KENT HIGHLANDS LANDFILL

CLEANUP ACTION PLAN

APRIL 1993

SUBJECT: Draft Cleanup Action Plan for Kent Highlands Landfill

Figure 2-1
Refuse Limits

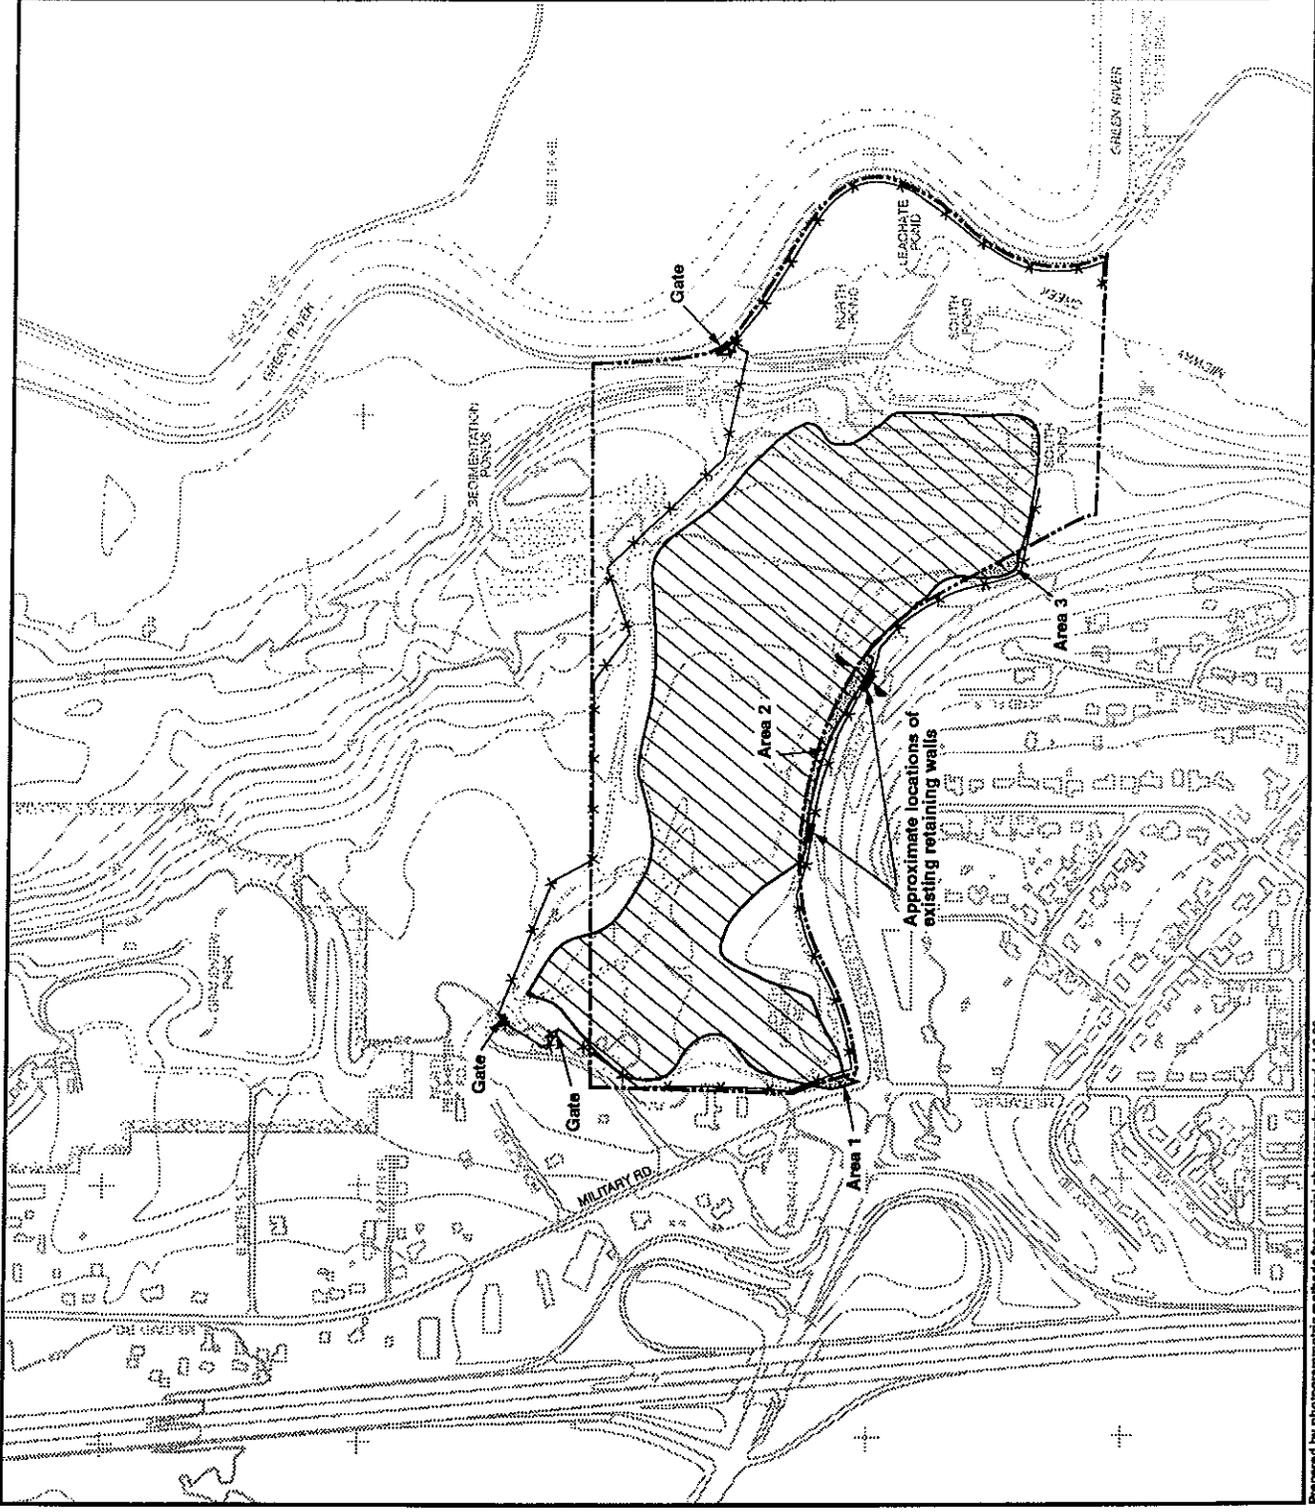
4. Figure 2-1 should be modified. Not all of the fence is currently completed as shown in this figure. Eliminate the cross-hatching in the area to the north; there is no legend for the cross-hatching, nor is there a real need to show it this way. Title the figure simply "Refuse Limits".

**Figure 4-5
Existing Gas Control
Systems**

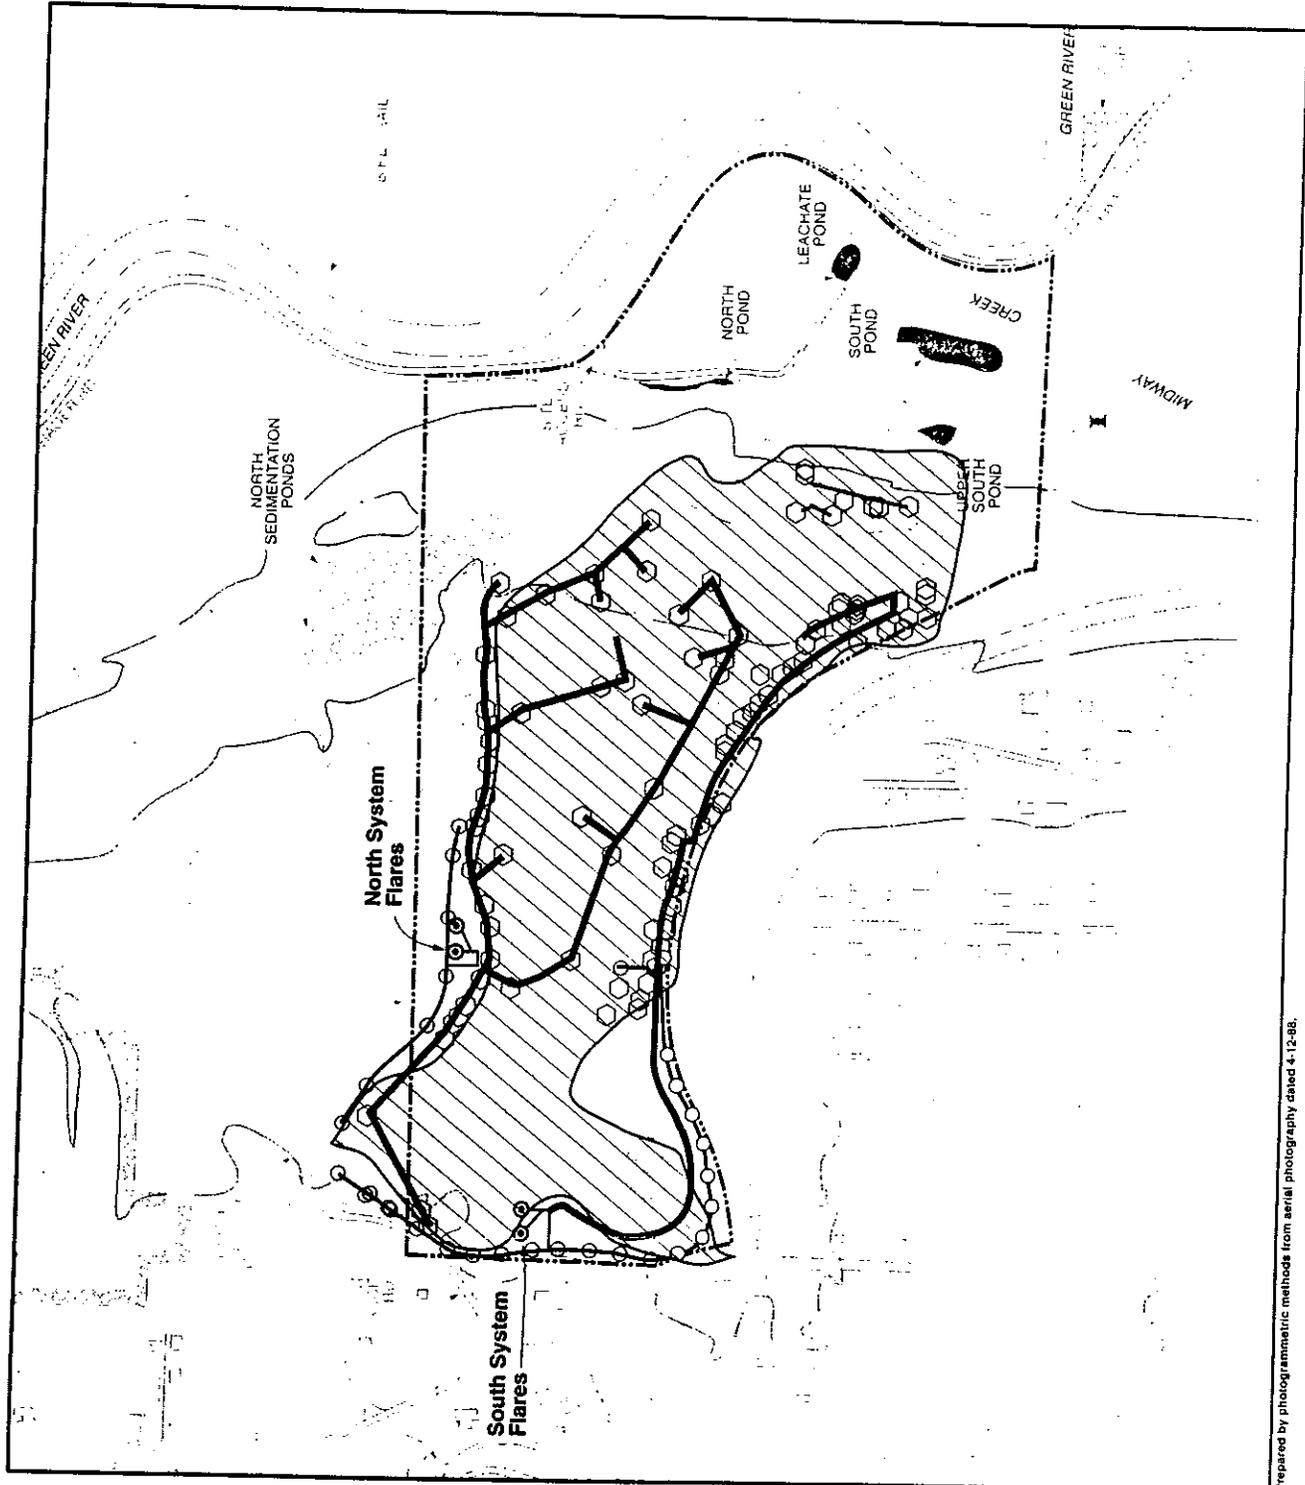
12. The figure reference on page 51 should be to Figure 4-5.
